Jun 12, 2000

SUBJECT: SUMMARY OF THE MAY 25, 2000, MEETING BETWEEN THE
NUCLEAR REGULATORY COMMISSION AND PRIVATE FUEL
STORAGE, LIMITED LIABILITY CORPORATION

Attachments: 1. Attendance List
2. List of Open Items
3. Graphic on Soil Stability

Figure 9.38 Shear stress versus total normal stress relationship at failure for the undrained test.

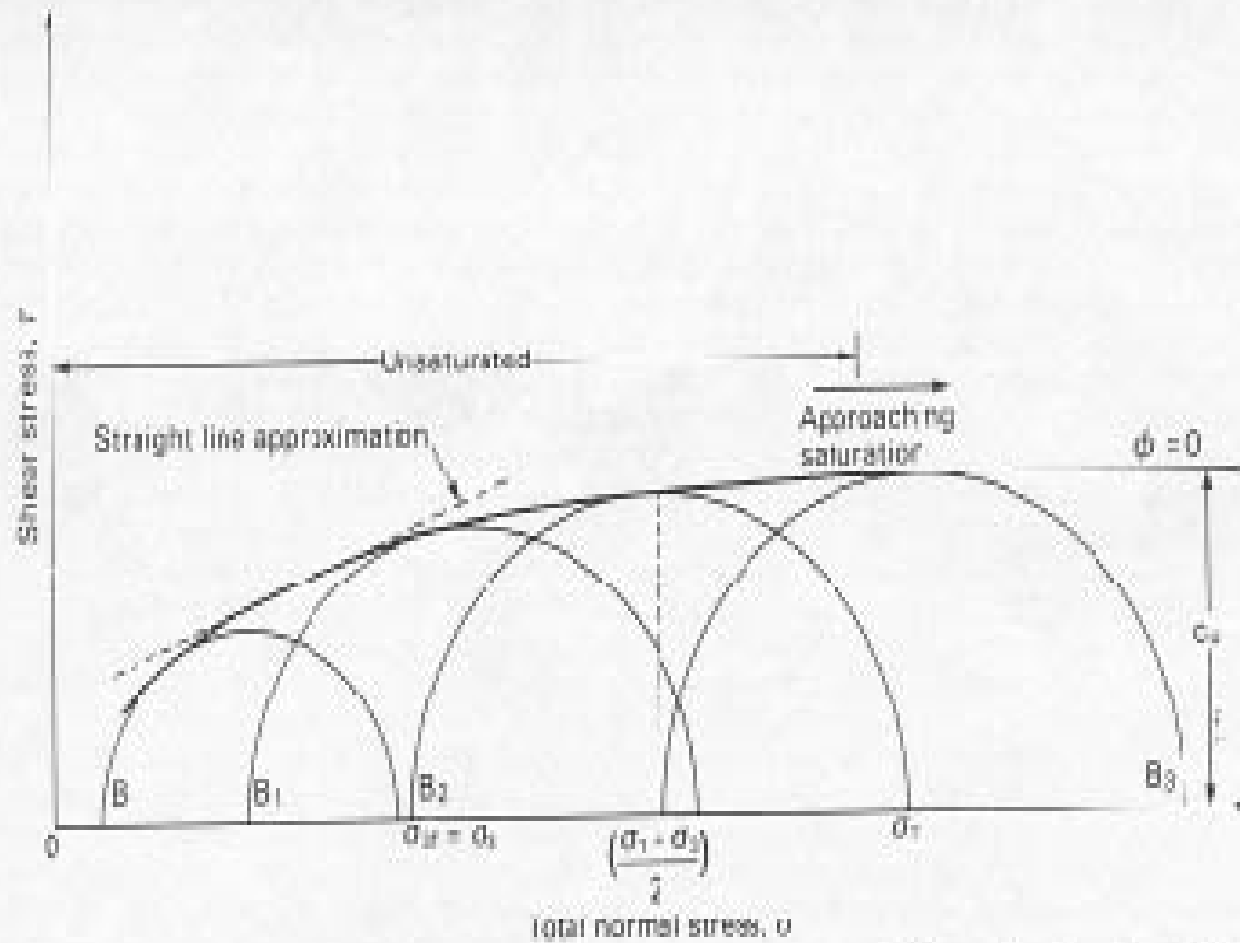
Attachment 2 is a list of the subjects of the open items discussed at the meeting. The two major areas discussed were (1) issues associated with the demonstration of the stability of the foundations of the storage pads and the canister transfer building, and (2) issues associated with military aircraft use of air space near the proposed PFS facility. During the course of the meeting, the staff described the information needed to complete the safety evaluation. With regard to the aircraft information, PFS representatives discussed their efforts to obtain information from the U.S. Department of the Air Force and recent efforts to complete its own analysis of this data, prior to submitting it to NRC. Attachment 3 was used by the NRC staff in the discussion of the first set of issues.
